4.I. 3226 Dogwood Drive Site Plan Review

Anequa Garmon is requesting site plan review to construct a new single-family dwelling at 3226 Dogwood Drive, Parcel Identification Number 14-0094-0001-015-5. The property is zoned V, Village and is subject to the zoning regulations of the City of Hapeville.

DEPARTMENT OF PLANNING AND ZONING
PLANNER'S REPORT

DATE: July 13, 2026
TO: Adrienne Senter
FROM: Lynn Patterson
RE: **Site Plan Review – 3226 Dogwood**

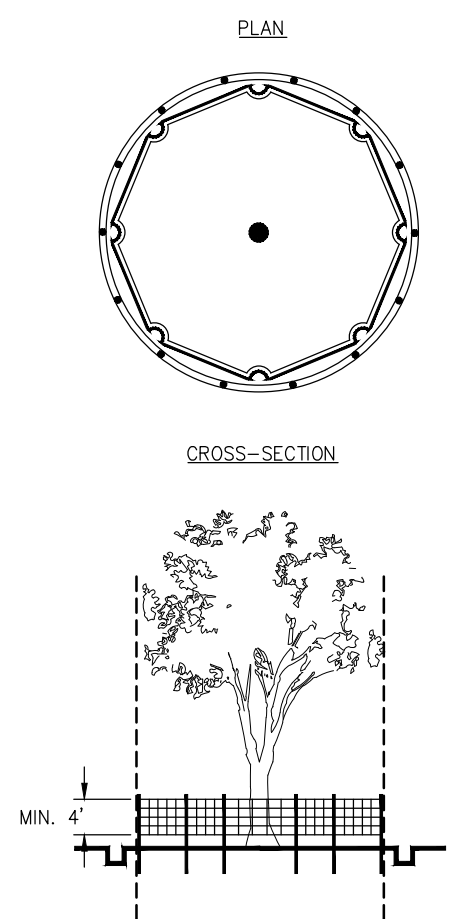
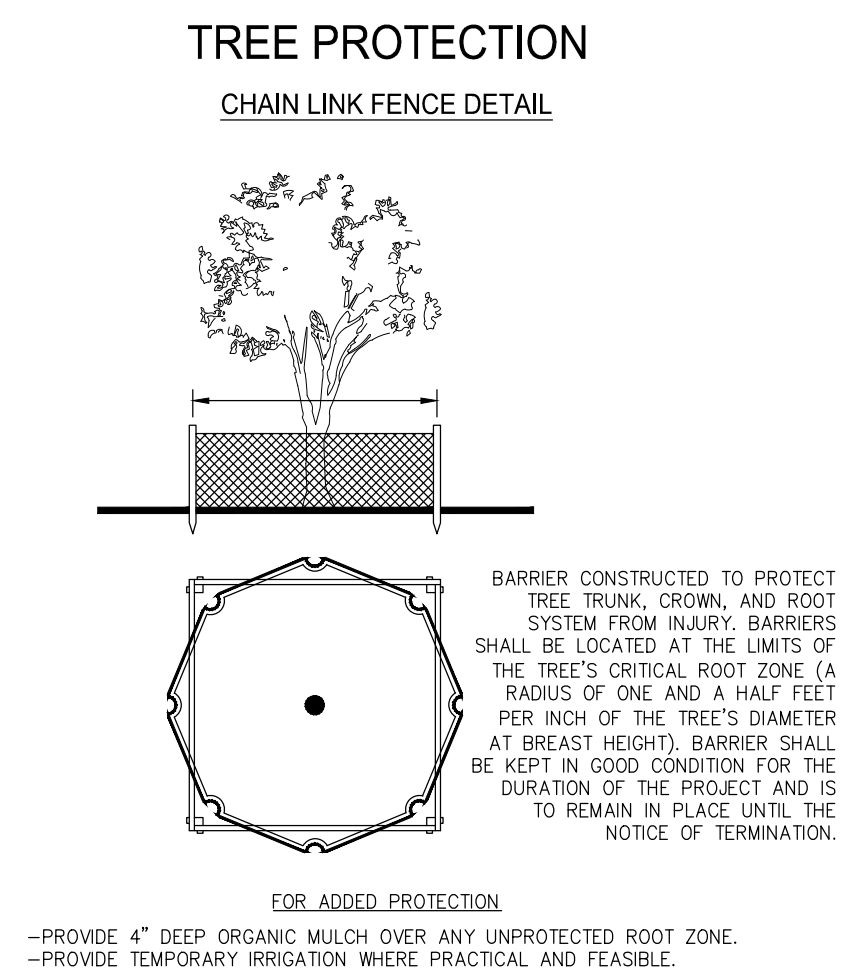
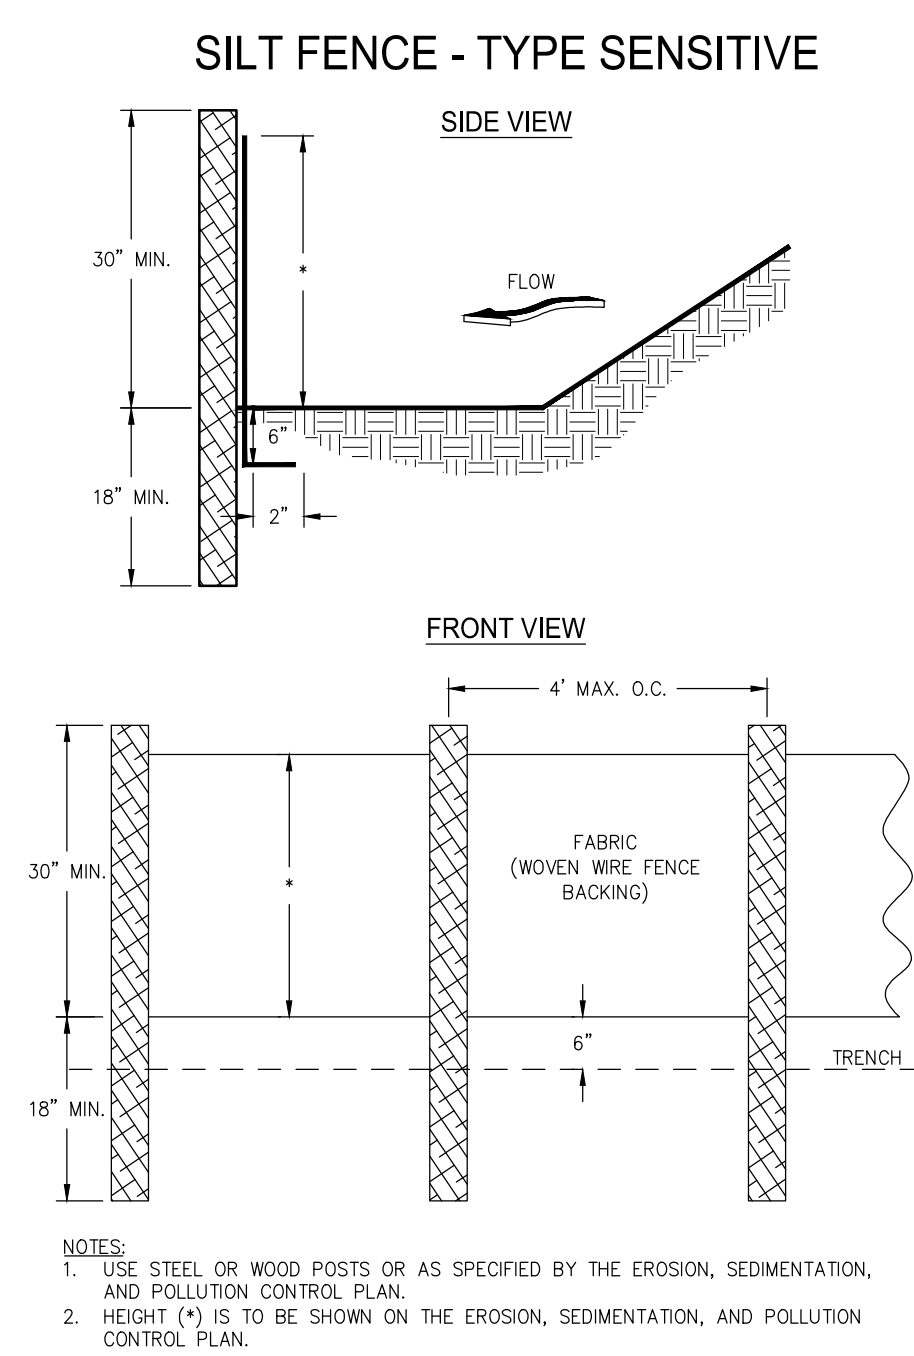
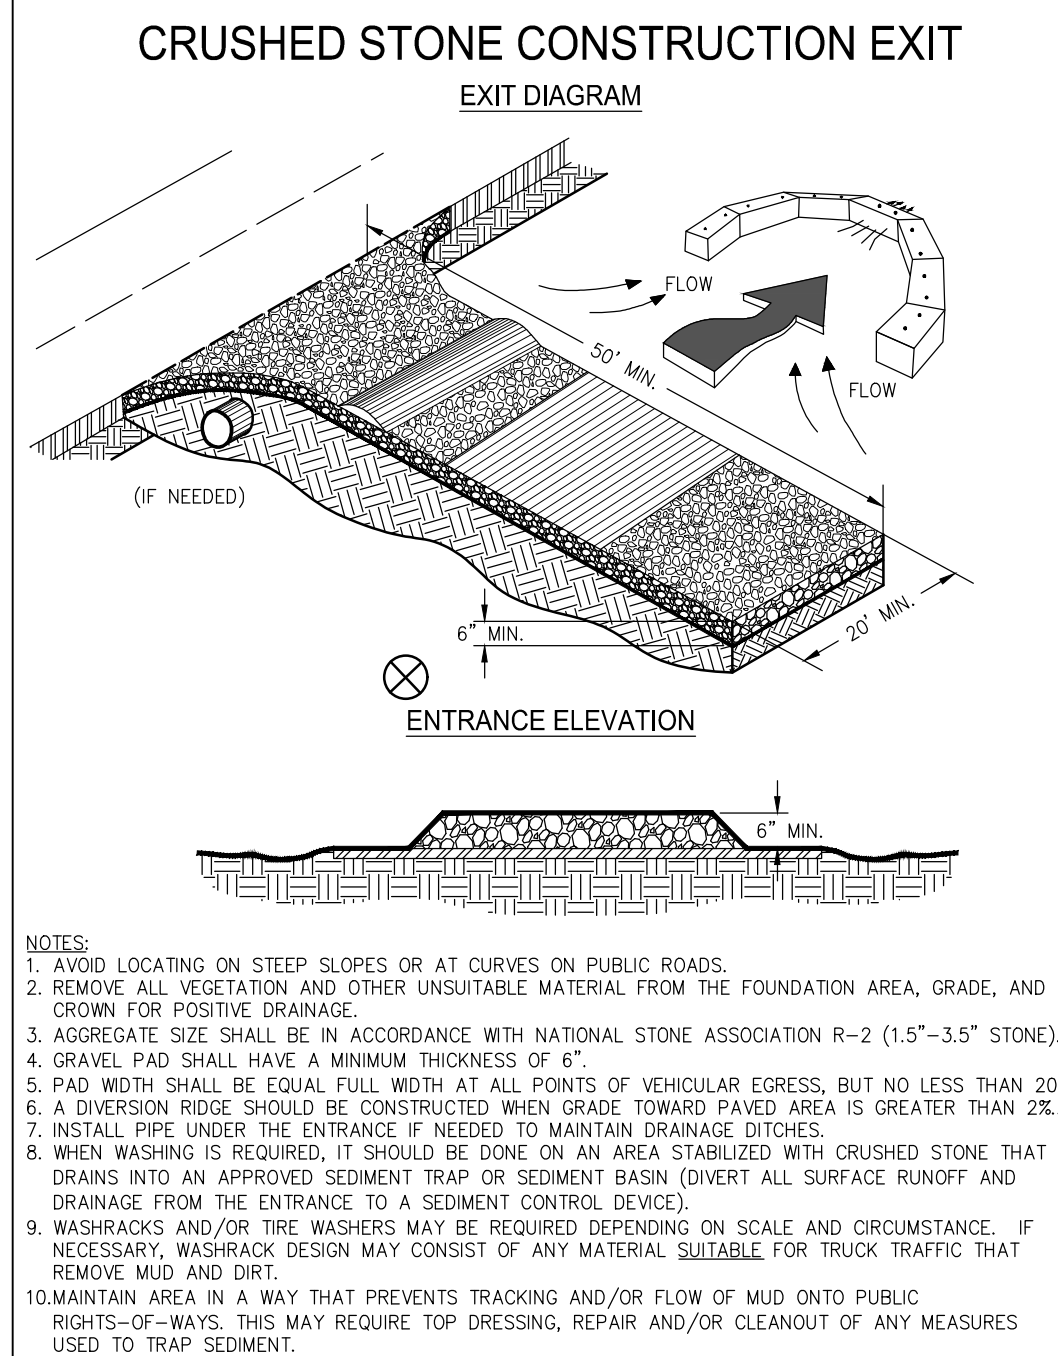
- Utility contacts on the cover sheet of the Civil Construction Drawings indicate Fulton County is the contact for water and sewer – this is incorrect – the City of Hapeville is the contact.

- The submitted CCD plans and the building elevations are not consistent. The CCD plan shows the front porch to the south and the mudroom door opening to the south – which is the side of the property that does not have a driveway - a previous iteration had the driveway on the south side of the property. The driveway is now located along the north side of the property with the parking pad. There is no access from the driveway to this door way as a 6' fence is located at the rear of the house.

SHEET NUMBER C2.00		3226 DOGWOOD DR HAPEVILLE, GA 30354		CITY STATE	
SITE PLAN DETAILS		CRER PROJECT DATE 5/1/26 SCALE AS SHOWN DESIGNED BY AM DRAWN BY AM CHECKED BY JR			
PREPARED FOR: ASTYLES HOME CONSTRUCTIONS				113 S PERRY STREET SUITE 206 13926 LAWRENCEVILLE, GA 30046	
No.		REVISIONS		DATE BY

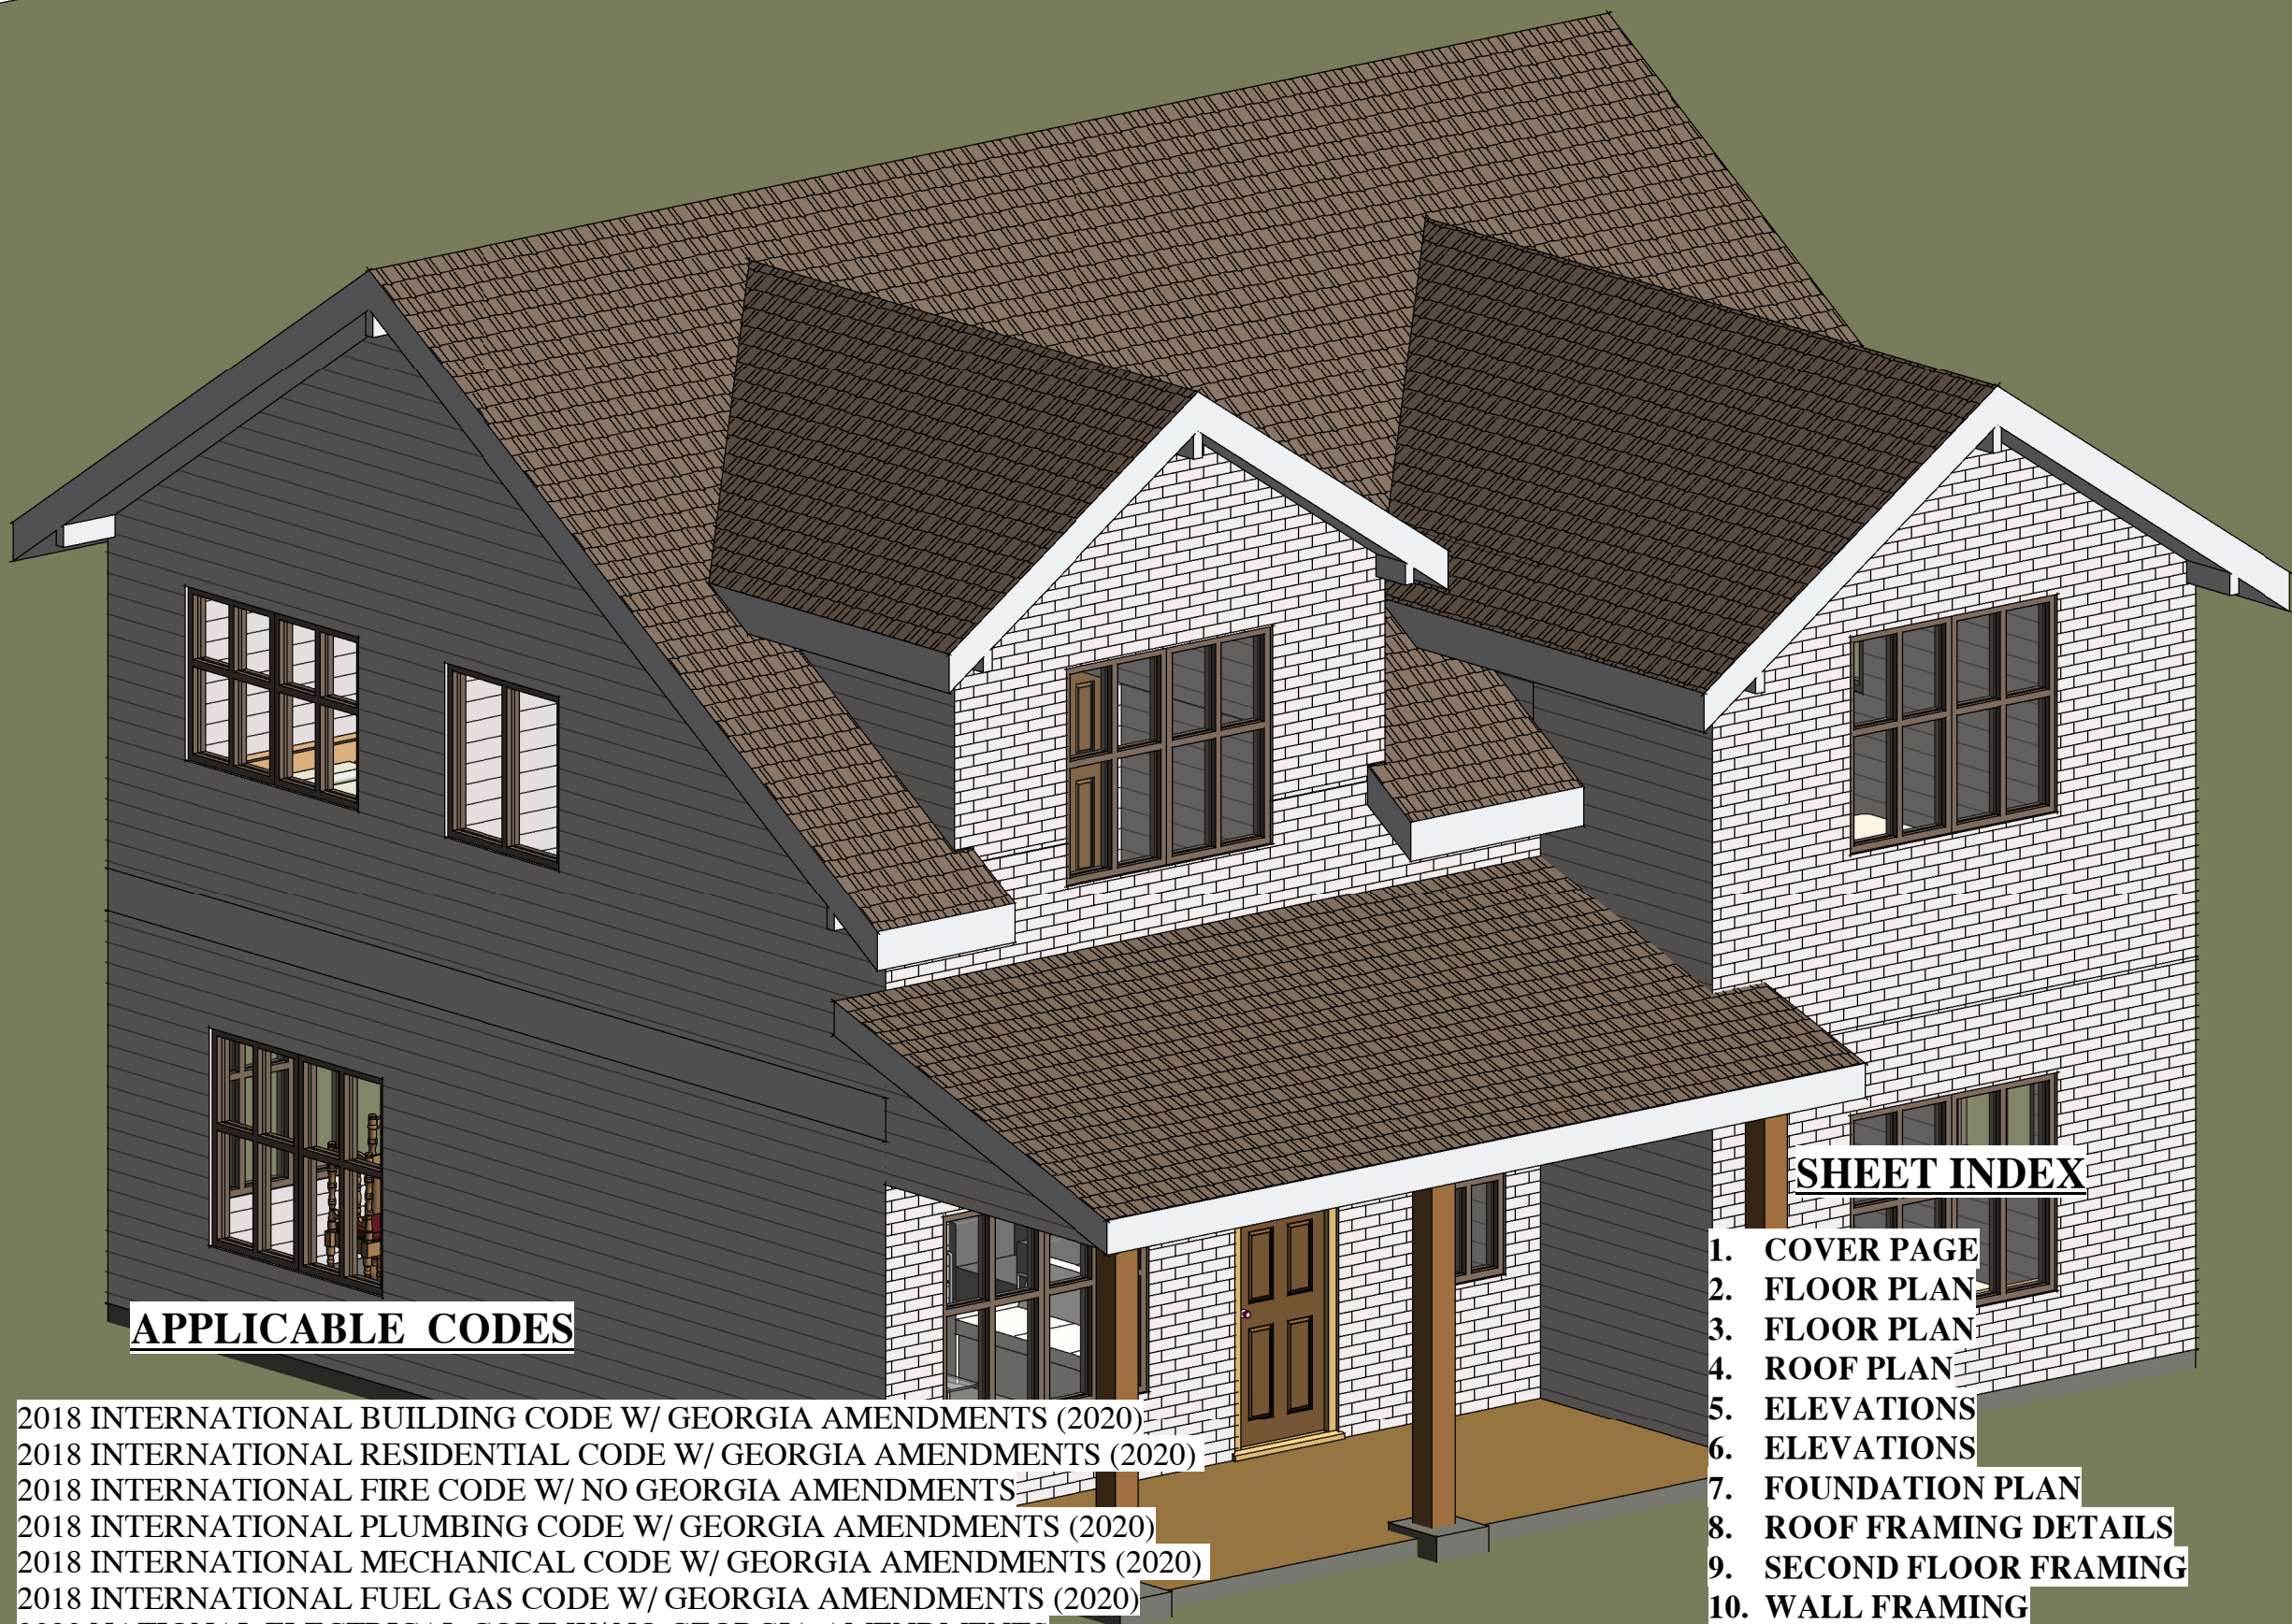
The dwelling is within the buildable area – please provide dimensions from property line to closest point of structure for side and rear setbacks.

Allowable is 70%. Site plan states impervious surface 1,732 SF or 28.8% which is not correct. The allocation has not been provided. The dwelling including the front porch is 1,128 the parking pad shown (too small) is shown as 520 SF, none of the driveways or sidewalks have been accounted for.

2 spaces. Area per above may not be sufficient for accessing parked cars and not having to back onto Dogwood Drive.
